Product Change Notice (PCN)

Subject: Part Marking Change for the Listed Intersil HSx-1840xxH / DLA SMD 5962-95630 Products

Publication Date: 8/18/2015

New Marking Configuration (SBDIP shown as example, all versions to have a 0 after ESD symbol – see MIL-PRF-38535 para:)

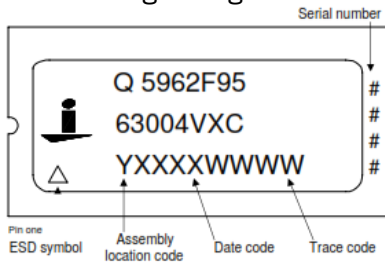
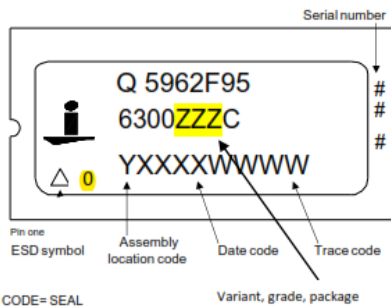
Modify HSx-1840xxH Brand to add ESD class code as defined in MIL-STD-883 TM3015 Table III.

Provide unit level identifier showing the ESD rating/sensitivity of this particular product. There is NO change to the ESD rating of the product.
